How safe is the proposed Tehri dam to earthquakes

R. N. Iyengar

Tehri dam, the construction of which has been stopped presently at a height of 20 m, has been surrounded by controversies. This article explains the main issues related to seismic analysis and design. Since the valley, at the dam site, is too narrow, three-dimensional effects have to be accounted for in the design. Also, the peak ground acceleration of 0.22 g recommended by the expert committee appointed by Govt. of India needs considerable upward revision.

Figure 1. Cross section of valley at Tehri dam site.

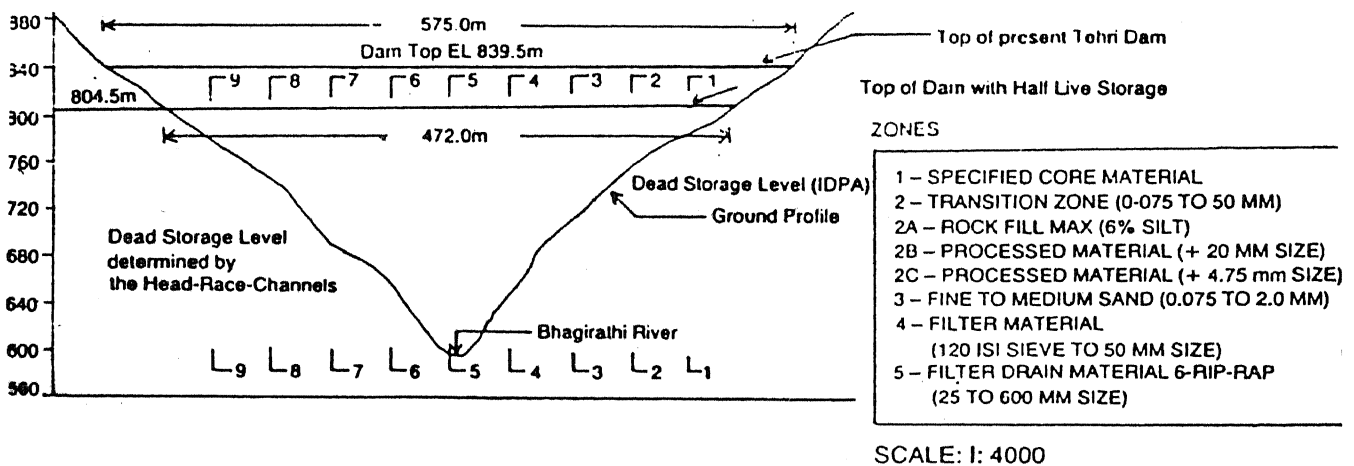
The reported natural periods in seconds are 2.272, 1.672, 1.476, 1.256, 1.087 and 1.104 for the central section. The corresponding figures for the abutment section are 1.504, 1.025, 0.952, 0.854, 0.753 and 0.640 seconds. These are presumably obtained by a finite element analysis of the section and are generally referred to as the two-dimensional values. The shear wave velocity $V_s = (G/\rho)^{1/2}$ for the dam material has been estimated to be 300–320 m/s. This gives from eq. (1) the first natural frequency at the central section to be $f_{1D} = 0.51$ hz ($T_1 = 1.96$ sec). This frequency is understandably higher than the two-dimensional value of $f_{2D} = 0.44$ hz, since in the latter case, not only the US-DS flexibility but also the vertical flexibility of the dam is included. However, neither of the theories is applicable at Tehri. The dam being constructed in a triangular valley with L/H nearly equal to 2, there will be severe stiffening due to the canyon walls, which calls for a three-dimensional analysis. The two-dimensional analysis can be justified only in the 'plane strain' case of the classical Theory of Elasticity. For this to happen, the (L/H) value should be more than six. The canyon

From the above considerations it appears that the Tehri dam (3-D) first natural frequency would be nearly equal to 0.8 hz (= 1.8/2.27). Furthermore, the section of the dam is not a neat triangle. At the mid section, the downstream arm is unusually short⁴. Also, the river bed

section and the abutment sections are geometrically dissimilar. Thus, the actual fundamental period of the dam is likely to be 1–1.25 seconds, which is roughly half the current reported value. The frequency spectrum of other modes which will contribute under an earthquake, are likely to extend at least up to about 0.3–0.5 seconds (2–3 hz). Thus, the view held by some engineers that the dam is very flexible and hence will not respond severely to the Himalayan earthquakes which have their energy concentrated in the high frequency end of the design seismic acceleration response spectrum, is not justified. The Soviet report¹² on the behaviour of the Tehri dam under the Gazli accelerogram does mention about the canyon effect but is obscured by the fact that only a 2-D analysis has been done that too on a section which differs from the one exhibited as the river bed section in the THDC report⁴. In any case only one component of the horizontal accelerogram has been used indicating that no longitudinal response studies were done, for understanding possible development of transverse cracks.

Figure 3. Plane versus three-dimensional analysis distribution with depth of peak response variables (dam: $H=120$ m; $V_s=280$ m/s, $\beta=0.1$) (Gazetas⁹).

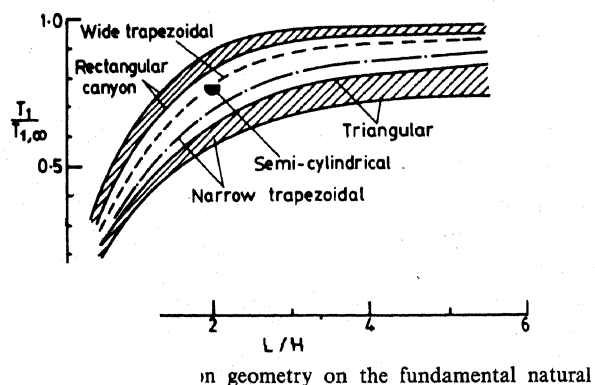
effect and the implications of it to seismic analysis are well known. The results are available in the open literature on earthquake engineering. There are two classical papers on this problem by Makdisi *et al.*⁶ and Mejia and Seed⁷. In the first paper⁶, the effect of a triangular canyon on the response of an earth dam has been studied in detail. It is shown that for a dam in a triangular canyon for $L/H = 2$, the three-dimensional fundamental frequency is 1.8 times the two-dimensional value. In a companion paper⁷ the seismic response of the Oroville dam, USA has been studied by two-dimensional and three-dimensional theories. This dam is in a triangular canyon with $L/H = 7$. The height of the dam is 235 m. The fundamental period of the dam is reported to be 0.78 seconds. To study the effect of a steeper canyon the same dam section but with $L/H = 2$ has also been studied. The three-dimensional fundamental frequency is found to be 50% higher than the two-dimensional value. Further their conclusion is 'for dams in steeper canyons than that of Oroville dam, the results seem to indicate that plane strain analyses of the maximum section and the quarter section of the dam

cannot simulate correctly the behaviour of the embankment, and that it is necessary in those cases to perform three-dimensional analysis to obtain satisfactory results for design purposes'. Dakoulas and Gazetas⁸ in their work on semi-cylindrical valleys published in 1986, compiled the known stiffening effects of canyons of five shapes (Figure 2). For any (L/H) value the triangular canyon has the highest stiffening. At (L/H)=2 the actual fundamental frequency is about 1.8 times the 2-D frequency. It is convincingly shown by Gazetas⁹ that this stiffening effect results in considerably higher displacements and accelerations (Figure 3) in the body of the dam during seismic excitation. However, the shear strains may not be very sensitive to the shape of the canyon. An important offshoot of the three-dimensional effect is the possibility of longitudinal vibration of the dam. Abdel-ghaffar and Scott¹⁰, Abdel-ghaffar and Koh¹¹ have analysed the measured response of Santa Felicia dam in Southern California under the San Fernando earthquake of February 9, 1971 and the Southern California earthquake of April 8, 1976. Interestingly, the dam is a rockfill dam 83.3 m in height with a crest length of 390 m. The canyon is roughly trapezoidal in shape. The 1971 earthquake caused a transverse crack attributed to longitudinal dynamic strains. The records parallel to the dam axis show in their spectrum, several strong peaks (corresponding to the longitudinal natural frequencies) with almost equal amounts of participation.

Figure 4. Accelerogram recorded at Koyna dam (1a gallery) for earthquake of 11 December 1967 (time of origin $t_0 = 04:21:17$ IST).

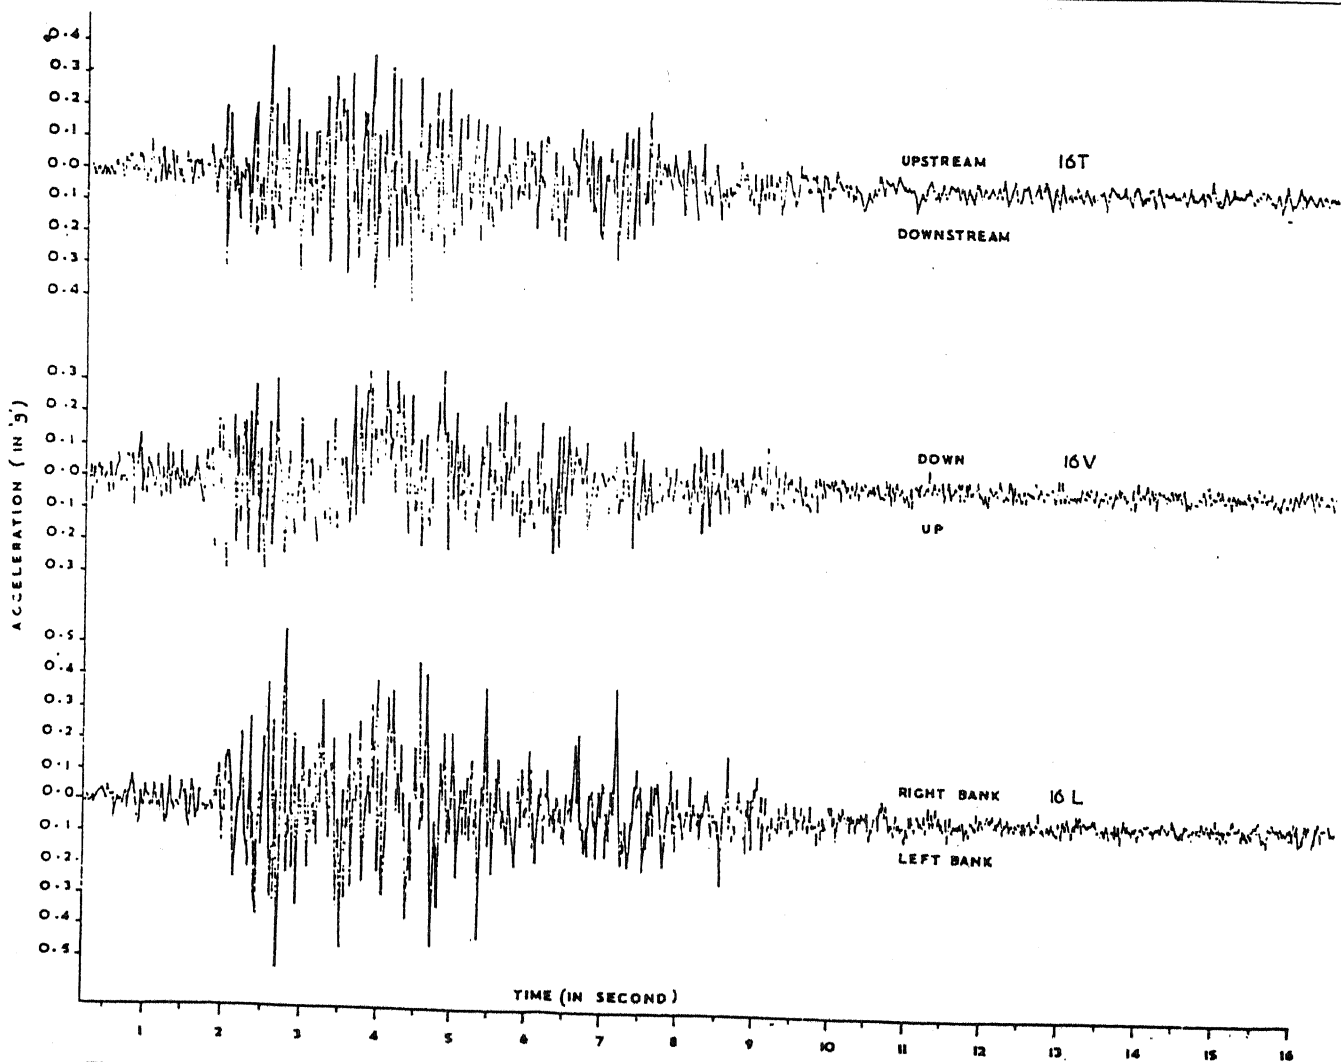
A typical strong earthquake accelerogram record is shown in Figure 4. A high isolated peak ($PGA \approx 0.5$ g) is clearly visible. The proponents of the EPGA concept will say that the effective PGA is however less than this value. Their main argument is to show that the response spectrum of the accelerogram would be relatively insensitive in the frequency range of interest, to variations in the isolated PGA value. This of course is a verifiable fact, but this is no proof that observed PGA values should be disbelieved. It is a reflection of the strong filtering property of the underdamped oscillator, which is not much affected by the PGA which sits as a high frequency kink. This cannot be the

basis for wishfully reducing a crucial seismic parameter such as PGA. If we have to follow the scientific approach of observation, analysis and inference, the instrumental recordings have to be believed and retained for whatever they are worth. The PGA as explained previously is a bench-mark with which the spectral shape will get multiplied to arrive at the MCE spectrum. Since EPGA is always less than PGA, acceptance of this concept could be construed as *erring on the unsafe side*. For small amplitude earthquakes, when the structural response will be linear, curtailing a high peak may not matter. But the same is not true with nonlinear systems. A rockfill dam like Tehri is highly nonlinear when the slope failure modes are analysed. Even though we do hear the concept of EPGA floated by some individuals now and then at conferences and meetings, it is not a universally accepted philosophy of design in earthquake engineering. The THDC report (p. 5) mentions about the PGA of 0.56 g recommended by NGRI and the EPGA of 0.25 g recommended by the DEE (Department of Earthquake Engineering, University of Roorkee). Further, in a valiant effort to justify the EPGA, the report says, 'For proper understanding of the difference between PGA and EPGA knowledge of dynamic analysis for dams is essential'. A typical case of putting-the-cart-before-the-horse syndrome! Further, the THDC report disappoints, to put it mildly, in telling, 'In a real accelerogram, the value of peak ground acceleration may be reduced without effecting its damage potential as the latter is not dependent upon single peak'. If the damage potential is not affected by the single high peak, as made out, why not allow it to be there, at least in public interest?
